CITY OF SAN ANTONIO

Re: Park Place Phase II (Amendment)

MDP # 748A

PARK PLACE PHASE II SUBDIVISION
 MASTER DEVELOPMENT PLAN #748A
 MARCH 2005

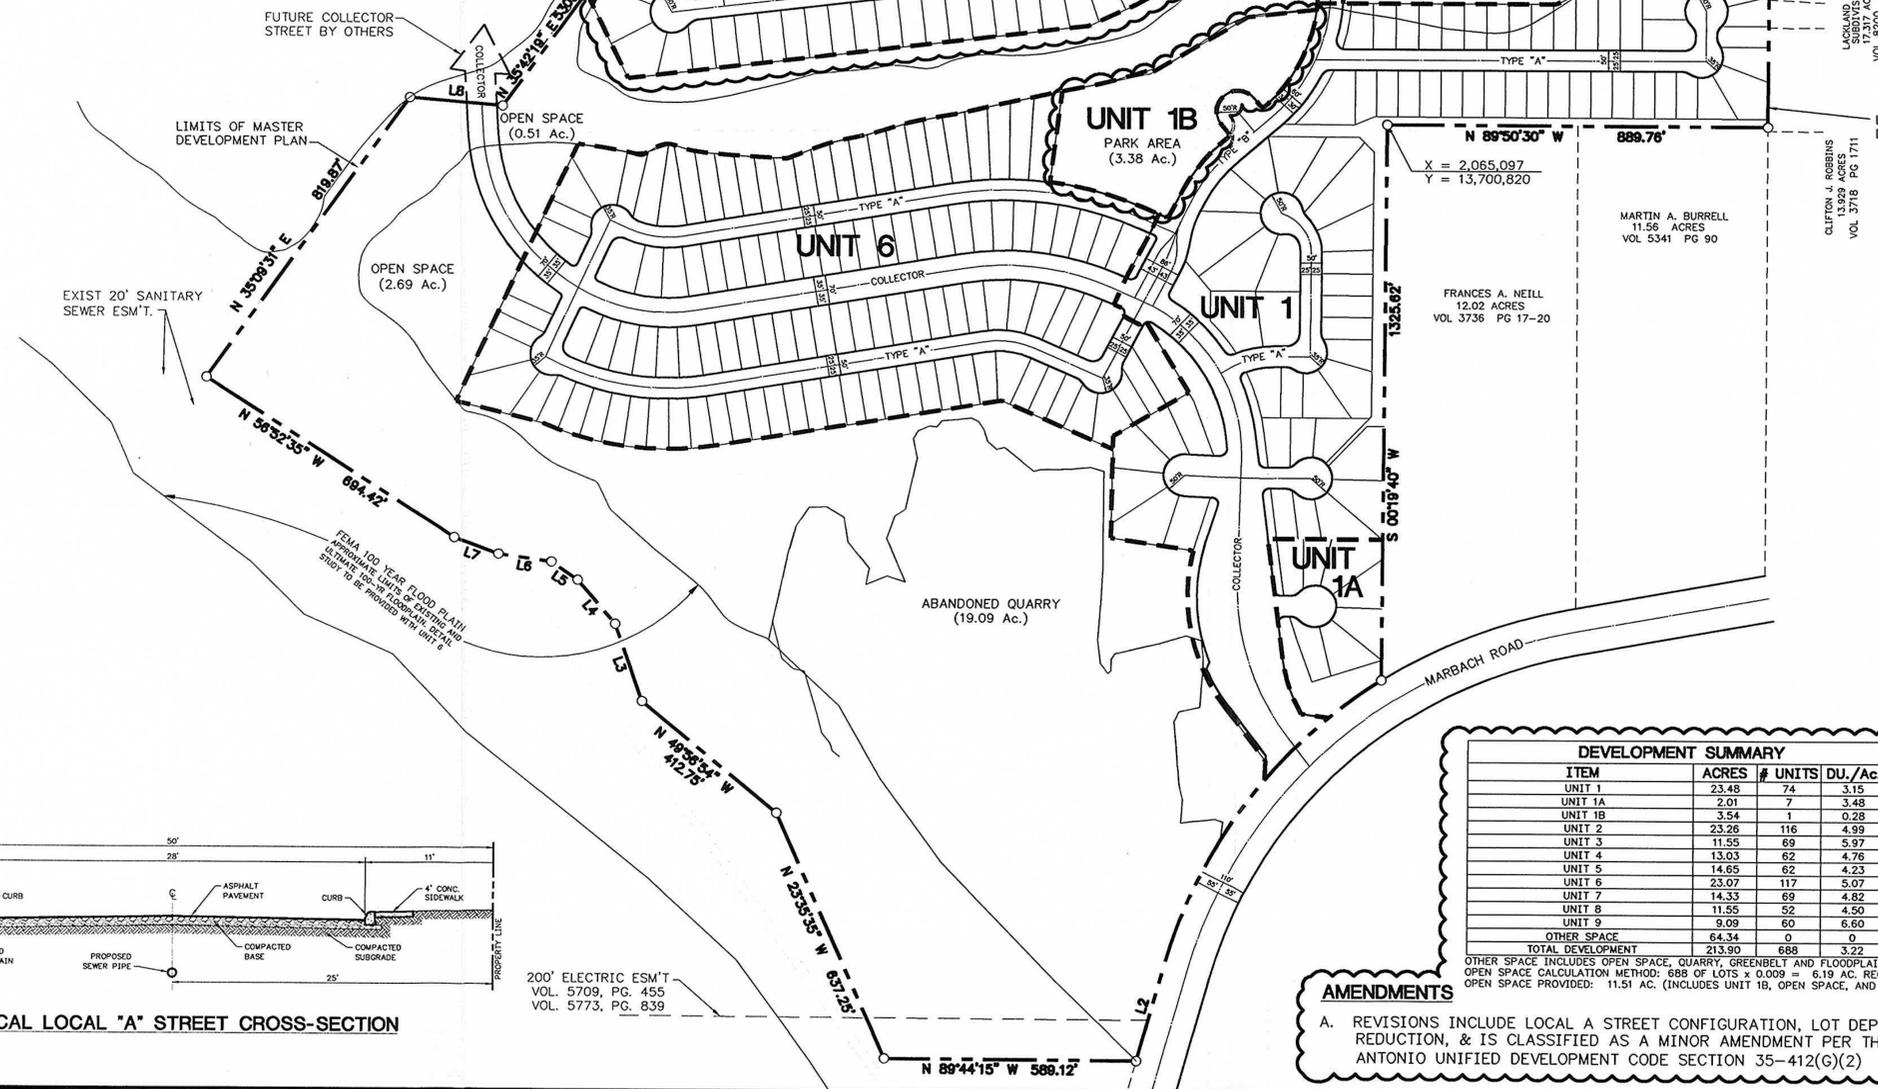
- In consideration of public safety and convenience, excessive grades by reason of topography should be avoided in street layouts and arrangements.
- Any access and R.O.W. issues along state facilities will need to be resolved with the Texas Department of Transportation (TXDOT). For information about these requirements you can contact TXDOT at 615-5814.
- This development will need to comply with tree preservation ordinance #85262. For information about these requirements you can contact Tree Preservation at 207-1111.
- It will be expected that you will plat all of the property depicted in your Master Development Plan (M.D.P) to include floodplains, drainage areas and open space.

- Development Services, TIA Engineering Section has indicated as part of their conditional approval, improvements along the project limits are necessary and shall be provided by the developer, on and before the completion of the Park Place II Development, at no cost to the City of San Antonio:

1. Construction of an internal collector street (Rousseau Road extension) approximately 3,140 feet in length. The collector shall consist of 70 -feet of ROW and 44- feet of pavement.

2. At the internal collector street (Rousseau Road extension) intersection at Marbach Road, the developer shall design and construct a westbound right-turn lane on Marbach Road (200 feet in length) when this intersection is constructed..

3. At the internal collector street (Rousseau Road extension) intersection at Marbach Road, the developer shall dedicate ROW (200-feet in length) to provide a southbound right-turn lane on the internal collector street (Rousseau Road extension) when this intersection is constructed.

4. The internal collector bridge (all weather crossing) over Medio Creek Tributary, which provides additional access to Park Place II, is required and must be in place prior to completion of the Unit and or Phase adjacent to Medio Creek Tributary.

5. The Local A bridge (all weather crossing) over Medio Creek Tributary shall be designed and constructed under the Phase 5 and or Unit 5. This all weather crossing is a east – west stub out adjacent to the northwest side of the proposed development as shown on the approved Master Development Plan.

6. The additional direct access point from Manor Creek Road (connecting Park Place to Rousseau Road extension) shall be connected once the area west of Park Place and Park Place II is constructed.
